XCAL-Series

Release Note

Doc Rev: 09

Product Version: 3.3.4.124

Title	[Setup Start Cond] in [AutoCall Setup]	Call Type	Data Call
Product	XCAL Series	Requestor	
Chipset		CRM#	
Location	[AutoCall Setup] window		
Description of Enhancement/Fixes

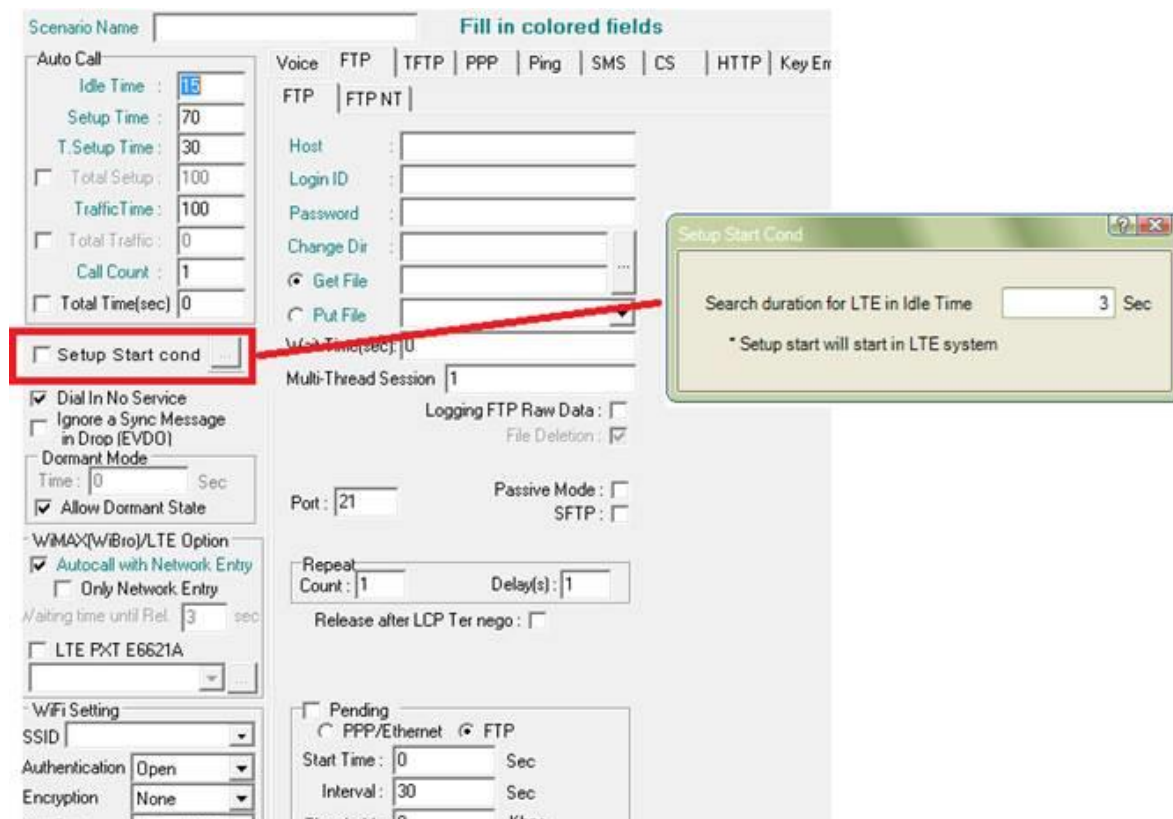
Added [Setup Start Cond] option in [AutoCall Setup] window for data calls (FTP, HTTP, PING, TFTP, PPP, VOD, UDP, Youtube, ADB Script).

Title	M2E Delay in User Defined		
Product	XCAL Series	Requestor	
Chipset		CRM#

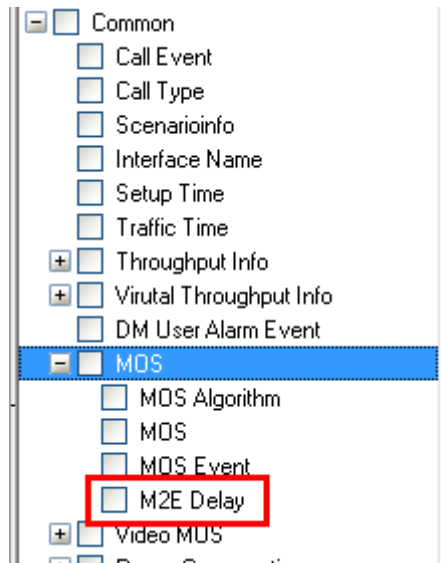
Added M2E Delay in [User Defined] windows.

Title	Reference Code of code -x41AC in [WQ Handoff Information] window		
Product	XCAL Series	Requestor	
Chipset		CRM#	
Location	[WCDMA Status] – [WQ Handoff Information] window		
Description of Enhancement/Fixes

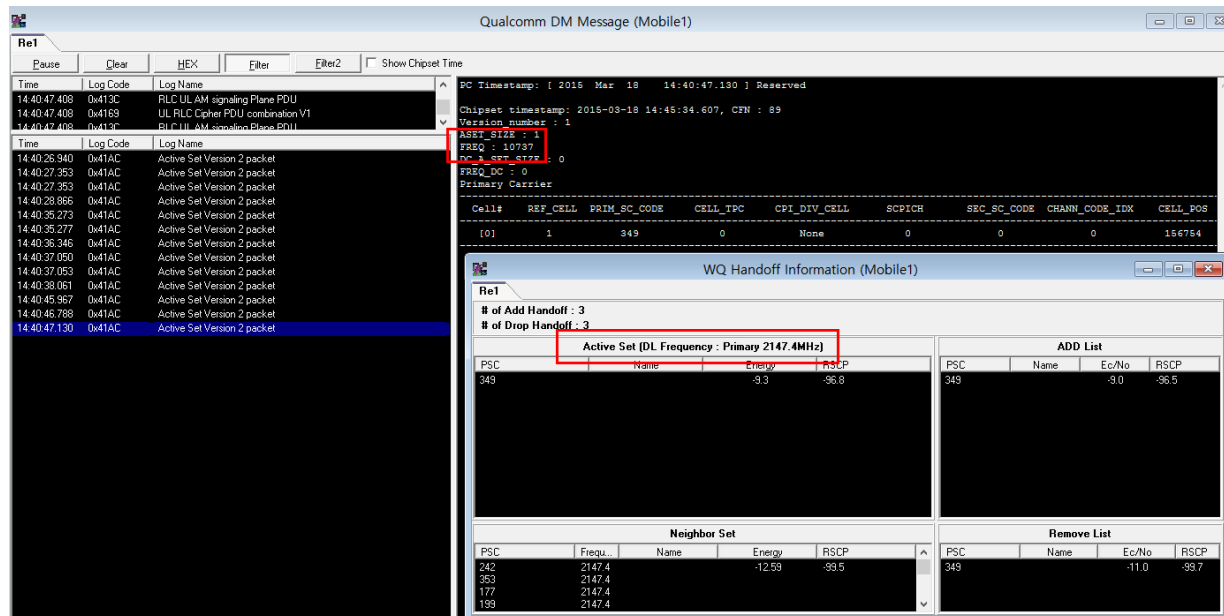
Added reference code of code0x41AC in [WQ Handoff Information] window.

Title	[HUQ L1&MAC Payload reason] Menu		
Product	XCAL Series	Requestor	
Chipset	Qualcomm	CRM#	
Location			
Description of Enhancement/Fixes

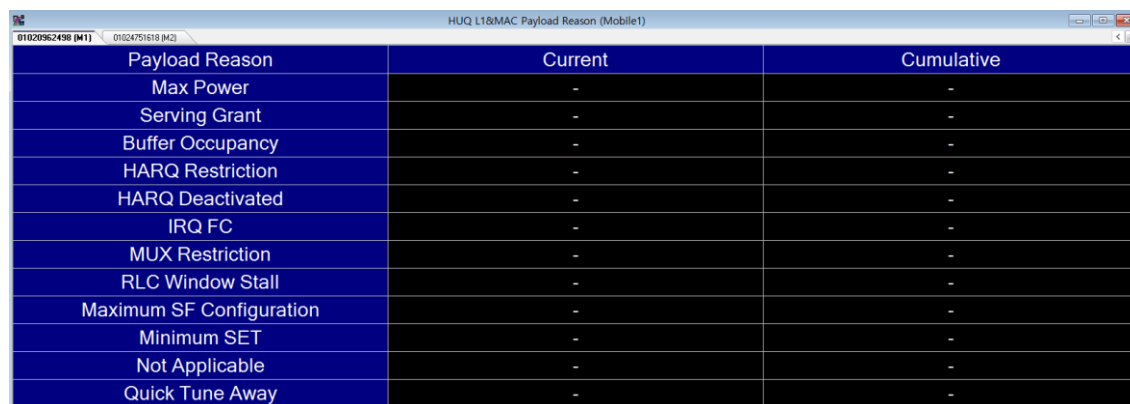
Added [HUQ L1&MAC Payload reason] Menu.

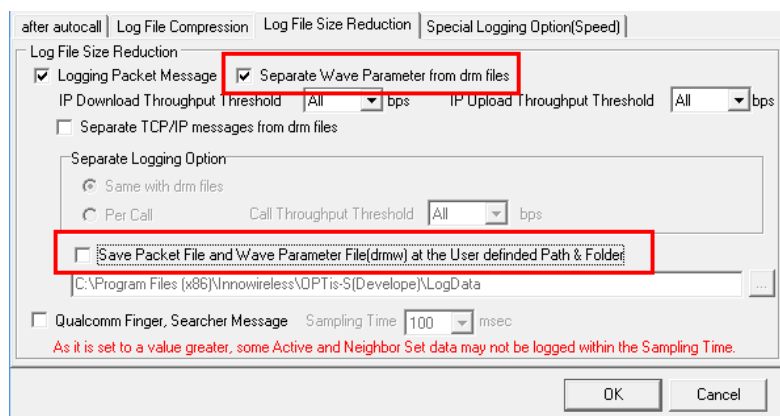
Renamed and changed the location of .drmwf option in [Log File Setting] window.

- [Save Packet File and Parameter File(drmwf) at the User defined Path & Folder] folder is activated only when [Separate Wave Parameter from drm files] is selected.

Title	Event Declaration referring to SIP message	Call Type	
Product	XCAL Series	Requestor	
Chipset		CRM#	
Location			
Description of Enhancement/Fixes

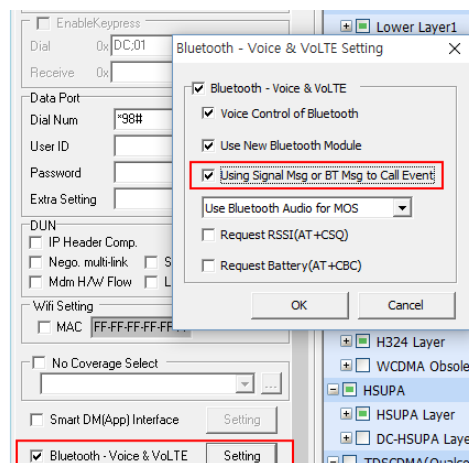
Changed to declare call events referring to SIP message even when Bluetooth – Voice & VoLTE -> Using Signal Msg or BT Msg to Call Event in Port Setting.

Title	CA Parameters in [LTE(Adv)-S Summary Graph] window		
Product	XCAL Series	Requestor	
Chipset	Samsung	CRM#	
Location	[LTE(Adv)-S Summary Graph] window		
Description of Enhancement/Fixes

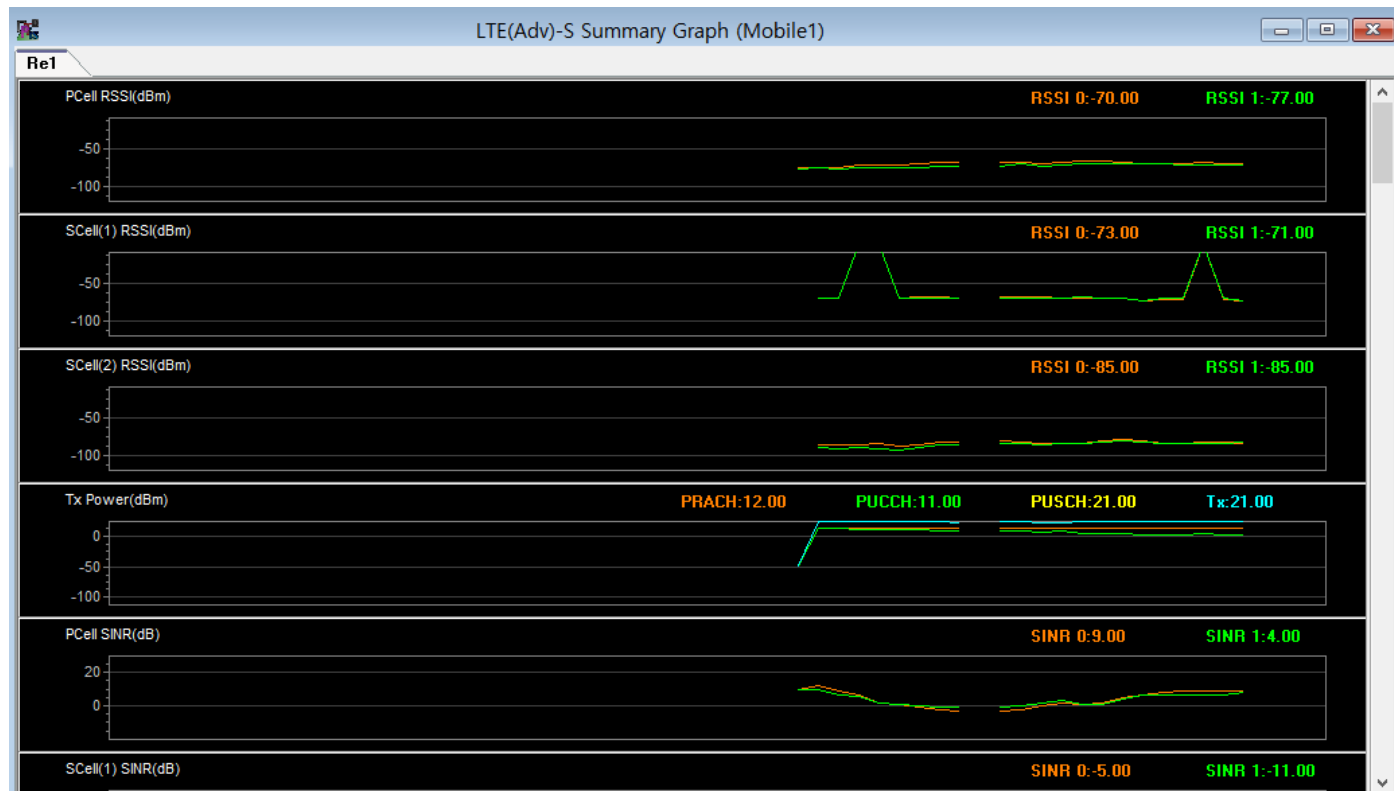
Added CA parameters in [LTE(Adv)-S Summary Graph].

Title	Search feature for LogMask, Event Report Message, Extended Mobile Message	Call Type	Common
Product	XCAL Series	Requestor	
Chipset	Common	CRM#	
Location	LogMask, Event Report Message, Extended Mobile Message		
Description of Enhancement/Fixes

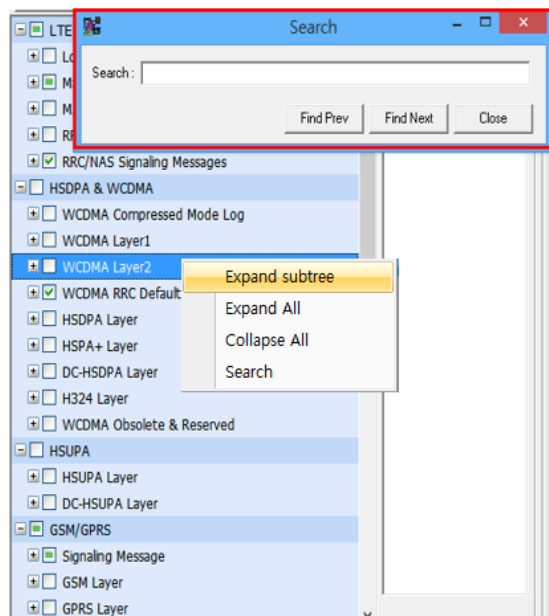
Added [Search] option for LogMask, Event Report Message, Extended Mobile Message by pressing Ctrl + F button on keyboard or right-click and select [Search] menu.

Title	[Delay Time between Traffic Start and MOS Start] option	Call Type	Common
Product	XCAL Series	Requestor	
Chipset	Common	CRM#	
Location	[AutoCall Scenario Setting] window – [Special Option] tab		
Description of Enhancement/Fixes

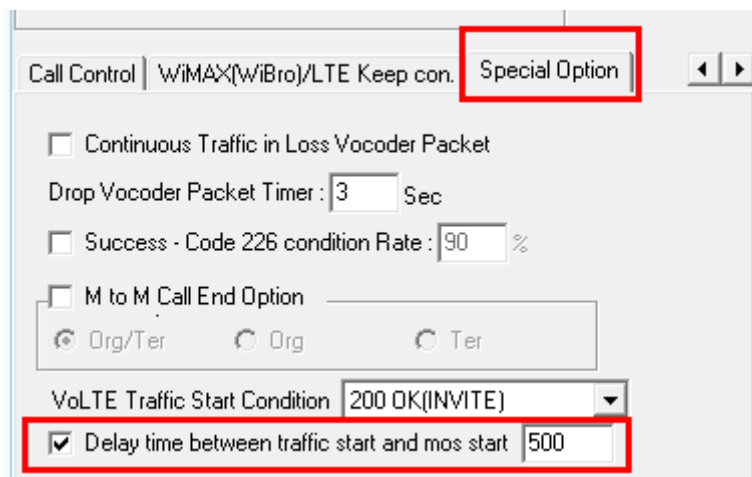
Added an option of [Delay Time between Traffic Start and MOS Start] to configure start of MOS test after Traffic Start.

Title	LTE-Q Phone Status		
Product	XCAL Series	Requestor	
Chipset	Qualcomm	CRM#	
Location	[LTE(Adv)-Q] menu – [LTE-Q Phone Status]		
Description of Enhancement/Fixes

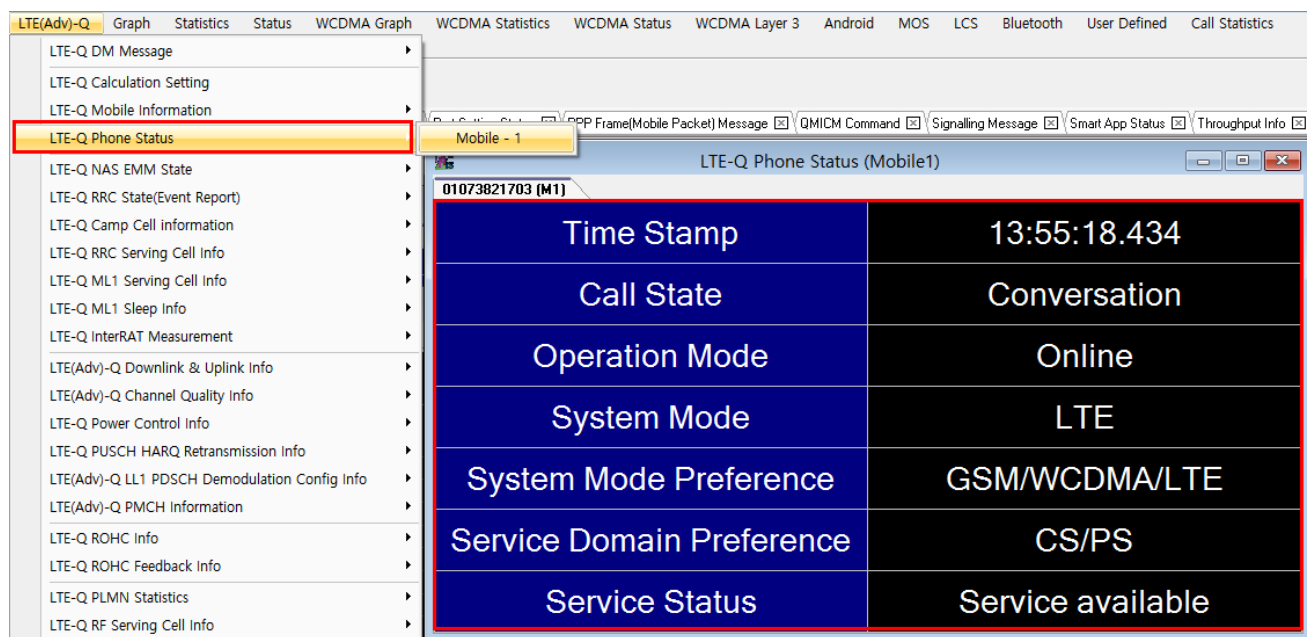
Added [LTE(Adv)-Q] menu – [LTE-Q Phone Status].

Title	DPL(Data Protocol Logging) for Phone Model		
Product	XCAL Series	Requestor	
Chipset	Qualcomm	CRM#	
Location	[Mobile Alias Setting] window		
Description of Enhancement/Fixes

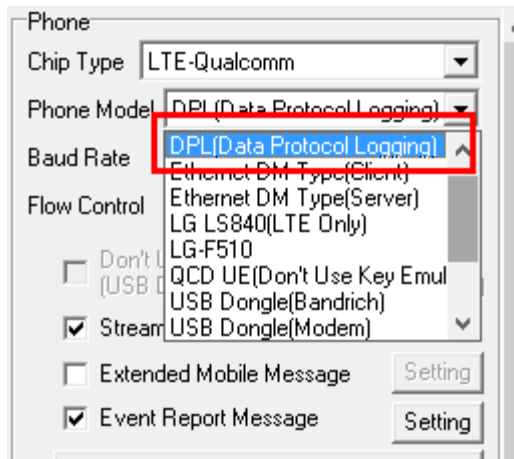
Added DPL (Data Protocol Logging) for phone models for LTE-Qualcomm chipset.

Title	WCDMA, GSM User Defined Cell Measurement		
Product	XCAL Series	Requestor	
Chipset	Samsung	CRM#	
Location			
Description of Enhancement/Fixes

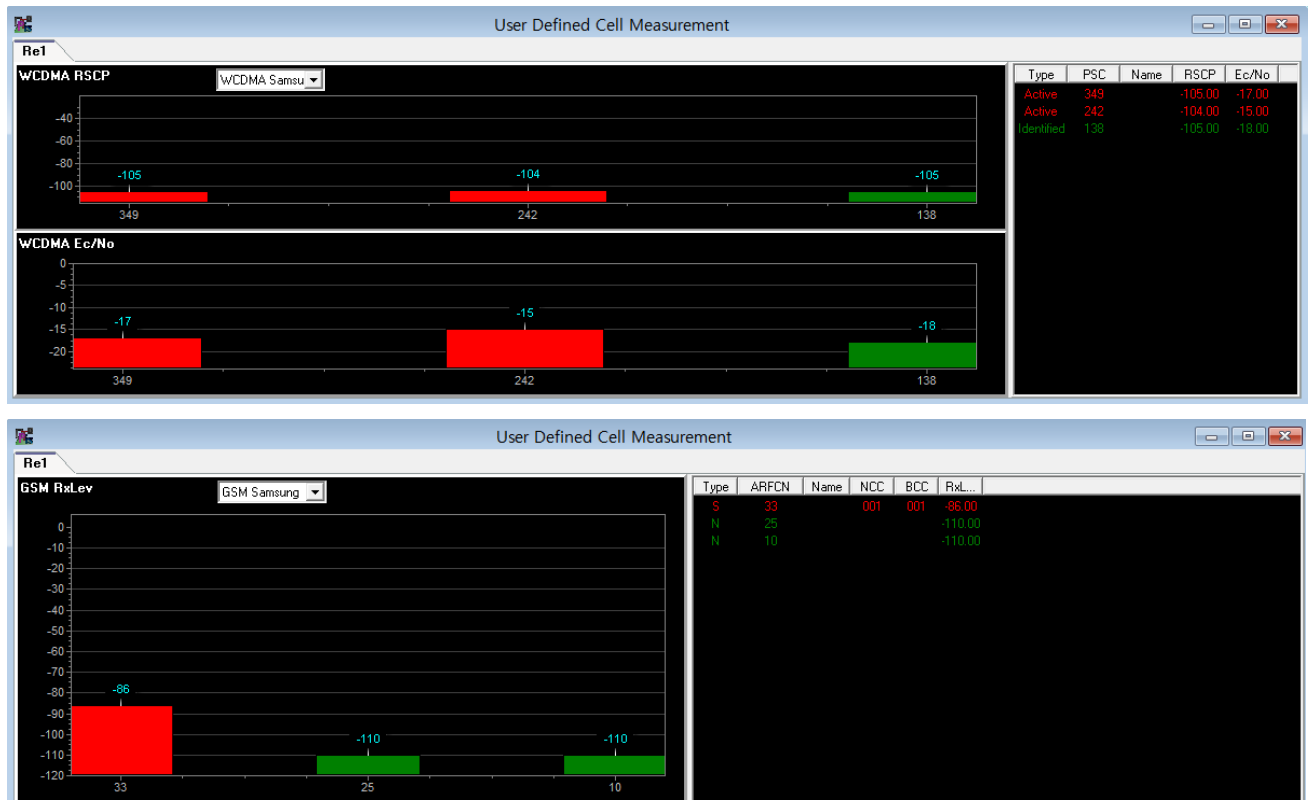
Added WCDMA, GSM User Defined Cell Measurement.

Title	UI in [Convert PPP Frames] window		
Product	XCAL Series	Requestor	
Chipset	Common	CRM#	
Location	[Convert PPP Frames] window		
Description of Enhancement/Fixes

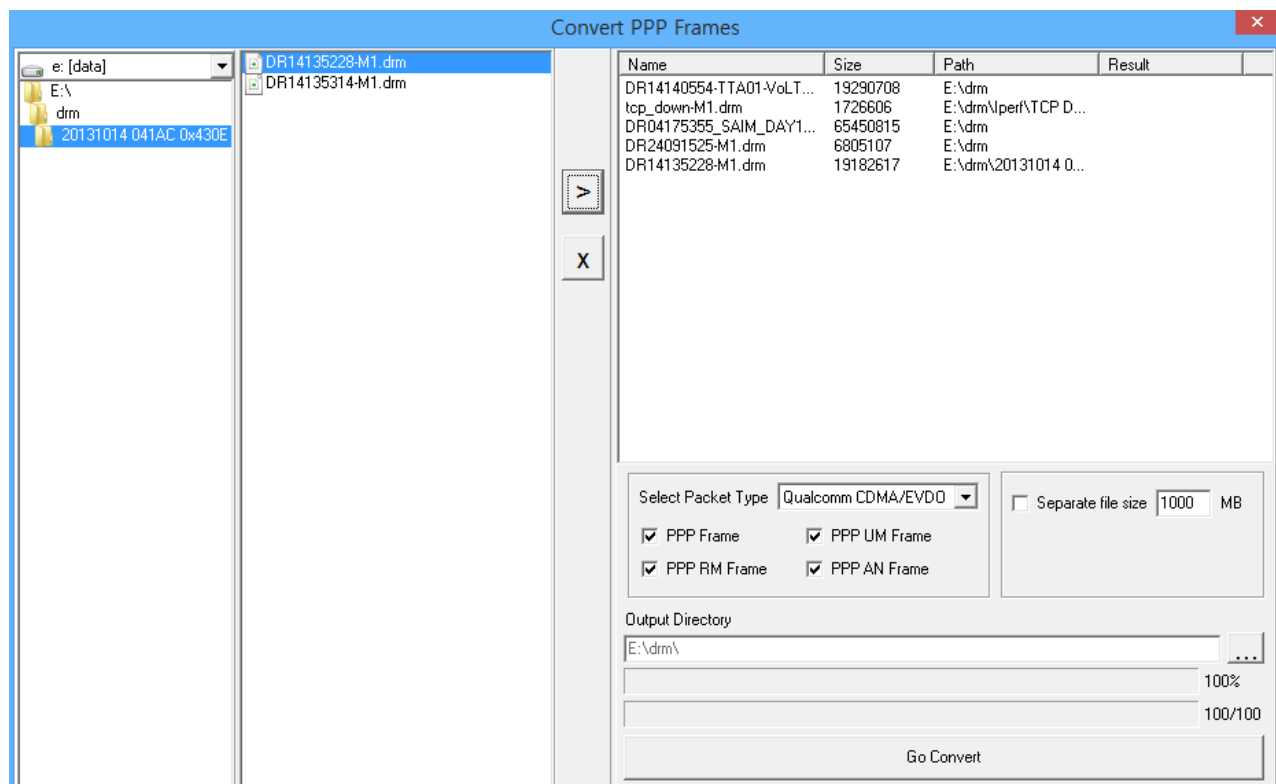
Changed UI of [Convert PPP Frame] window to convert files in different directories at once.

Title	[Reset Option] in [Multi Option]	Call Type	
Product	XCAL multi series	Requestor	
Chipset	Common	CRM#	
Location			
Description of Enhancement/Fixes

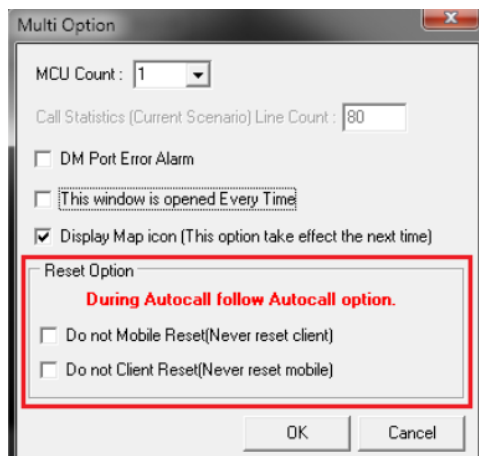
Changed to remove [Reset Option] in Multi Option for XCAL Multi series products.

Title	Play Quality in Youtube Play Info (Smart)	Tech	
Product	XCAL-Smart	Requestor	
Chipset	Common	CRM#	
Description of Enhancement/Fixes

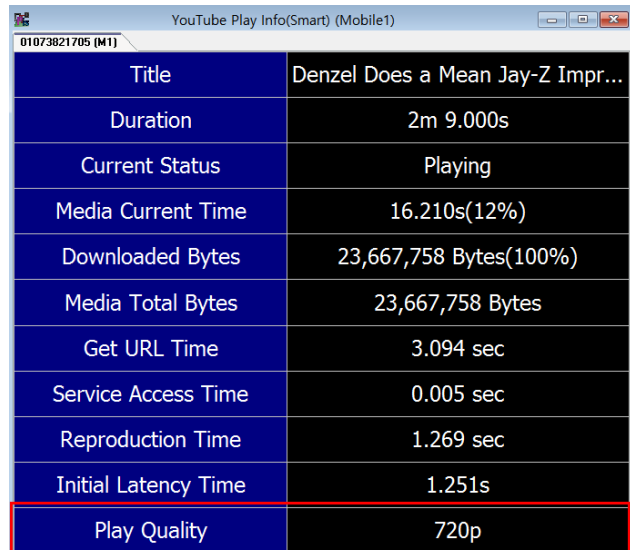
Added Play Quality in Youtube Play Info window.

Title	VoLTE Traffic Start Condition	Tech	VoLTE
Product	XCAL-Series	Requestor	
Chipset	Common	CRM#	
Description of Enhancement/Fixes

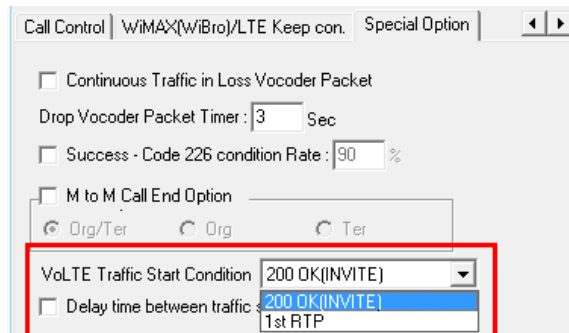
Added to configure Traffic Start Condition for VoLTE test.

Title	XCAL-Smart Update	Tech	
Product	XCAL-Smart	Requestor	
Chipset	Common	CRM#	
Description of Enhancement/Fixes

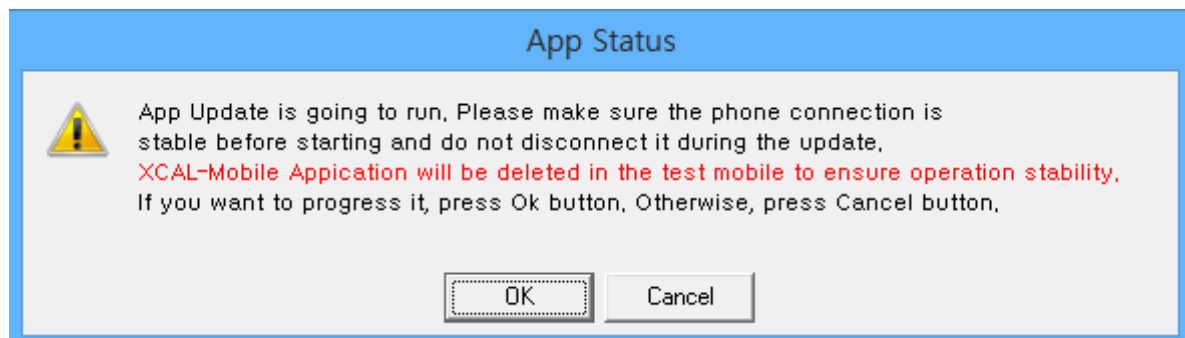
Changed XCAL-Smart update pop-up screen UI in Statistics/Status – Smart App Status.

Title	UMTS NAS Tree in Signaling Message Filter	Tech	
Product	XCAL Series	Requestor	
Chipset	Common	CRM#	
Description of Enhancement/Fixes

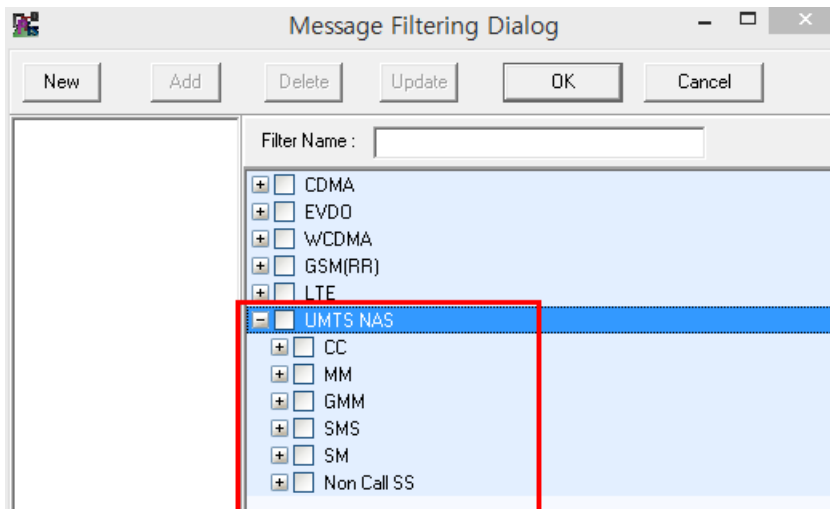
Added UMTS NAS Tree in Signaling Message Filter.

Title	Additional SIP Port for SNS	Tech	AutoCall
Product	XCAL Series	Requestor	
Chipset	Common	CRM#	
Description of Enhancement/Fixes

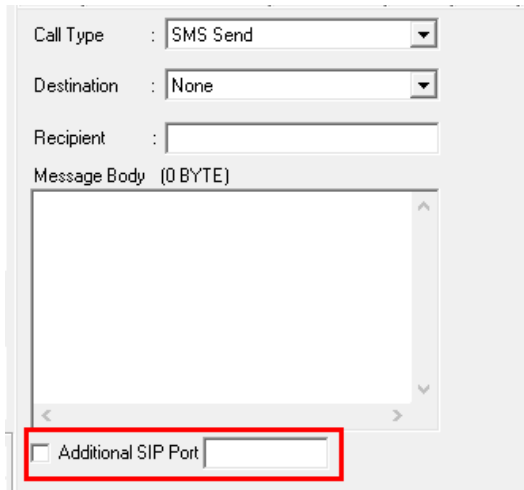
Added Additional SIP Port for SNS (Android) AutoCall test configuration.

Title	HUQ EUL Power Control Graph, HUQ Summary Graph	Tech	
Product	XCAL Series	Requestor	
Chipset	Qualcomm	CRM#	
Description of Enhancement/Fixes

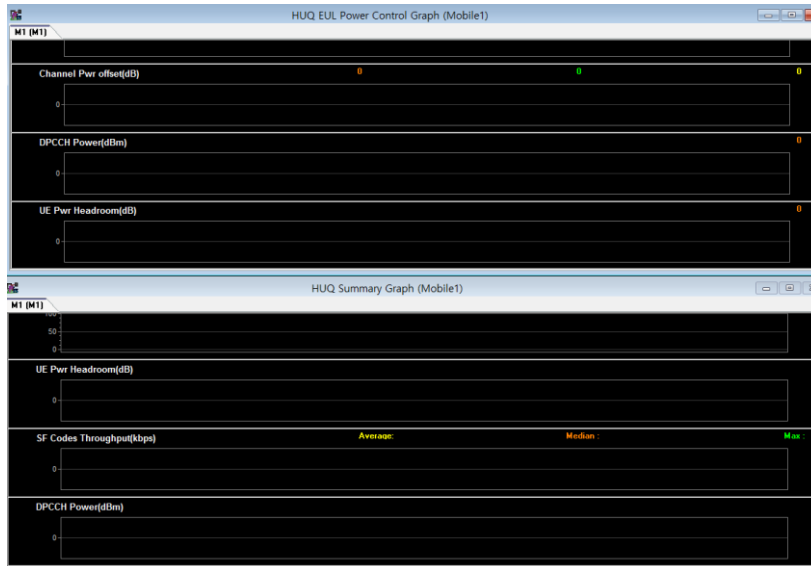
Added *Multi Carrier EUL E-TFC Restriction(0x435D)* in **HUQ EUL Power Control Graph** window and **HUQ Summary Graph** window.

Title	MOS Signal Graph Display	Tech	
Product	XCAL Series	Requestor	
Chipset	Common	CRM#	
Description of Enhancement/Fixes

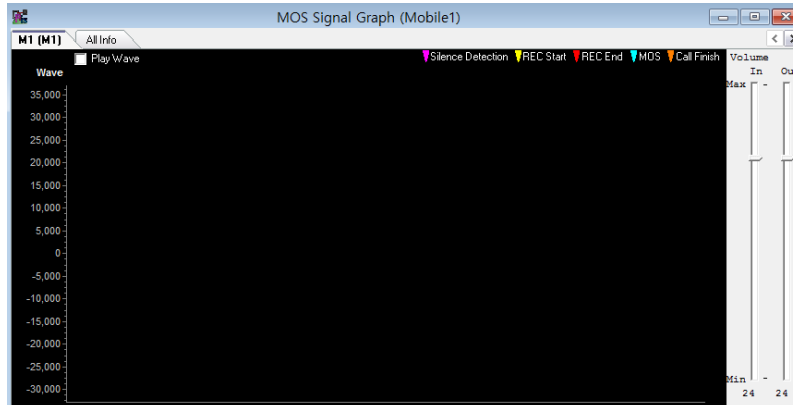
Changed to display MOS Signal Graph window only when there is relevant data.

Title	Deletion of Map Manager to use MapX File button for MapX 4.x and MapX 5.x	Tech	Map
Product	XCAL Series	Requestor	
Chipset	Common	CRM#	
Description of Enhancement/Fixes

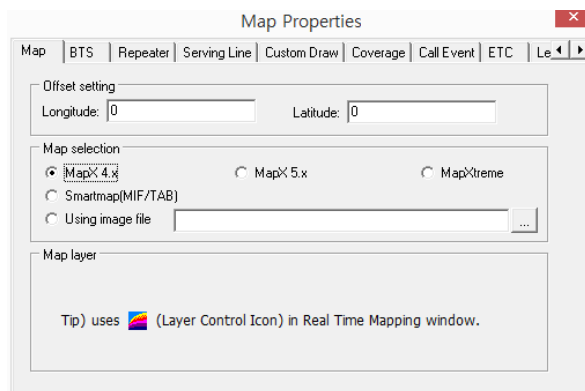
Changed to delete **Map Manager to use MapX File** button for **MapX 4.x** and **MapX 5.x**.
